LIMESTONE REVISIONS NOTE:

DOUGLAS STREETSCAPES

TOWER DETAILS

LS 6.03

3 TYPICAL ELEVATION
1/2" = 1'-0"

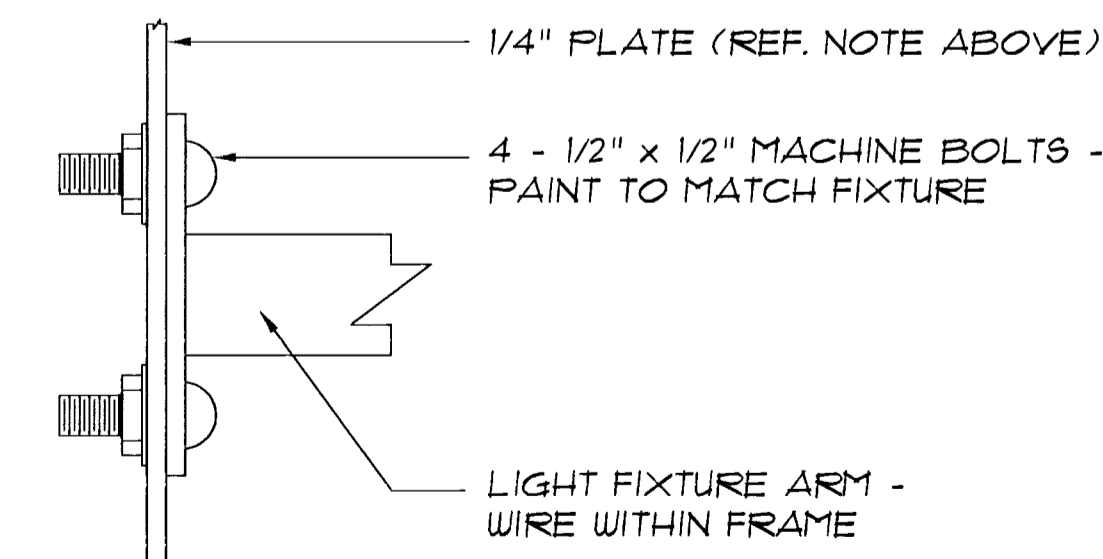
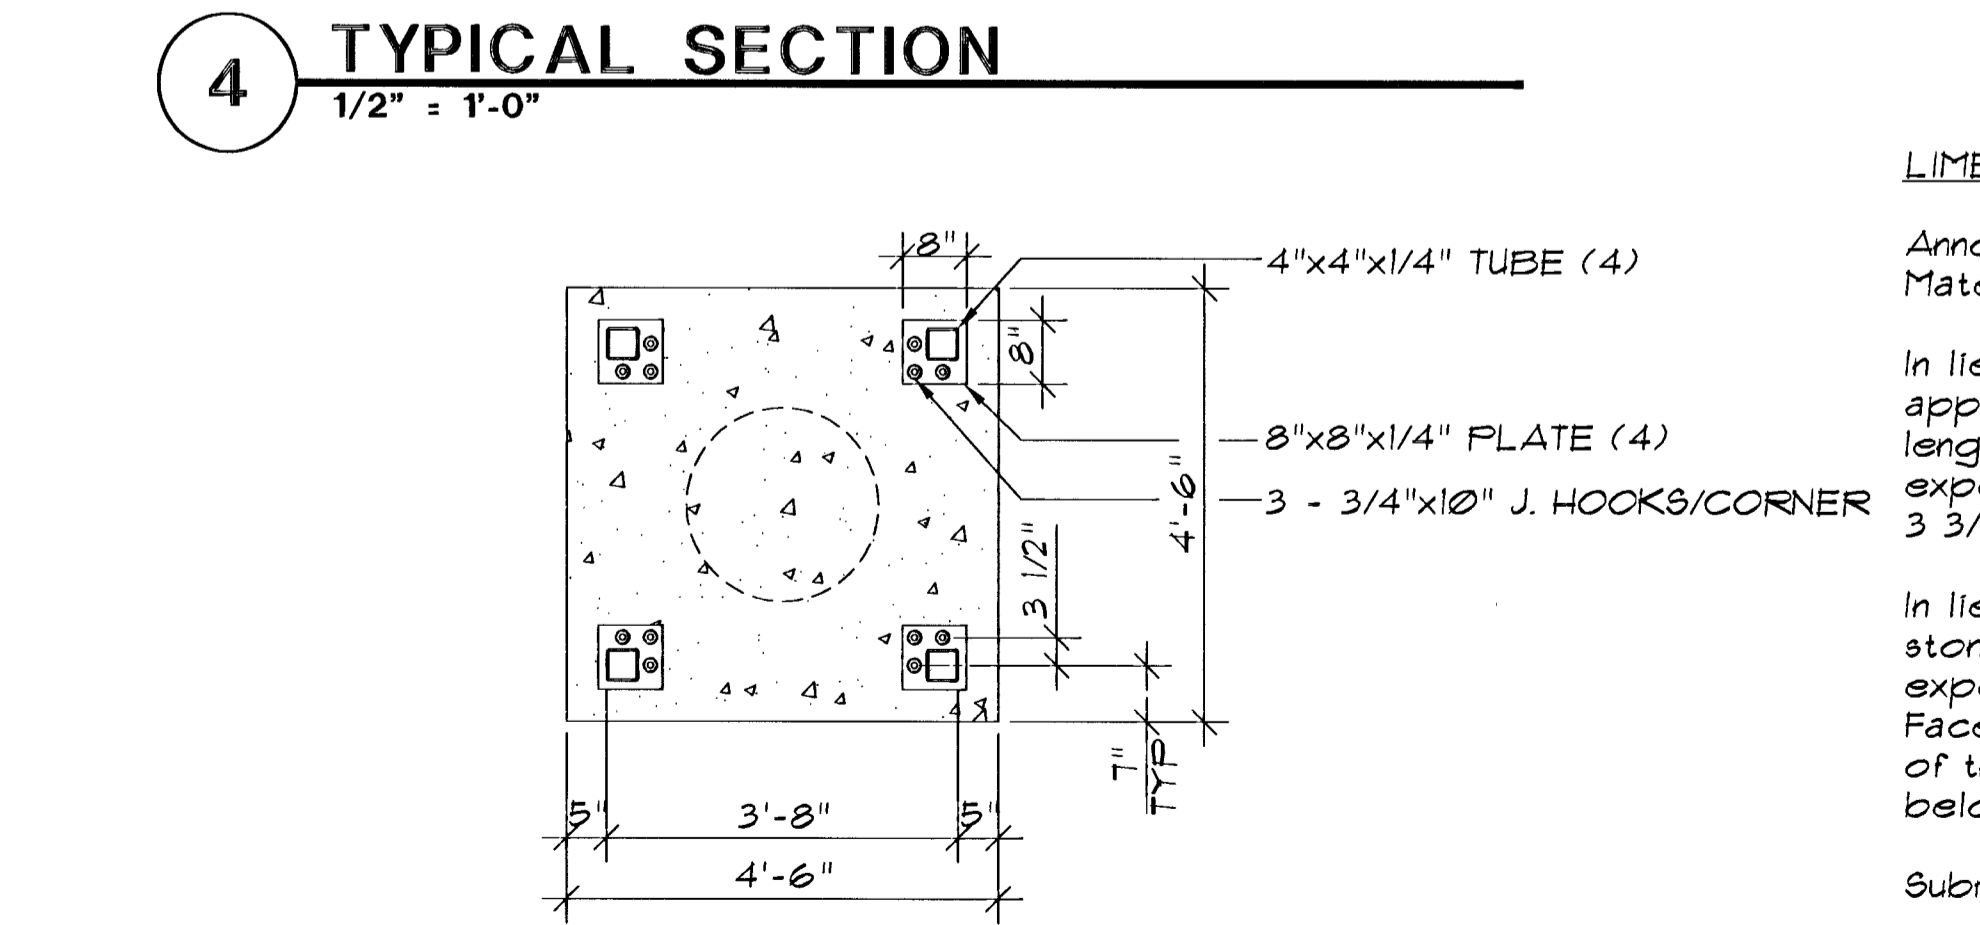
Annotations to Specifications, Section 04210 Stone Masonry Work, Part 2.00 Materials, 2.01 Limestone, and Drawings Sheet LS 6.03.

In lieu of Rubble Limestone, the stone veneer pattern is to be of approximately equal 8" height horizontal courses, with random 12" to 18" ± face lengths with staggered vertical joints. Texture of face and ends where exposed shall be Natural Cleft, Pitched Face. Bed thickness to nominal 3 3/4"-4".

In lieu of the 4" height (vertical dimension) cap stone, provide 8" height cap stone, with Natural Cleft, Pitched Face, texture on face, and ends where exposed. Texture on top surface of cap stone to be Natural Cleft, Pitched Face if possible or Split Face is acceptable on the top surface. The face of the cap stone is to be in approximately the same plane as the stone face below versus the 1 1/2" overhang as detailed.

Submit shop drawings of the stone veneer tower bases for approval.

Samples: Submit a minimum of two sets of samples approximately 6"x6" in size. Each set is to include the full range of exposed color and texture to be expected in the completed work.
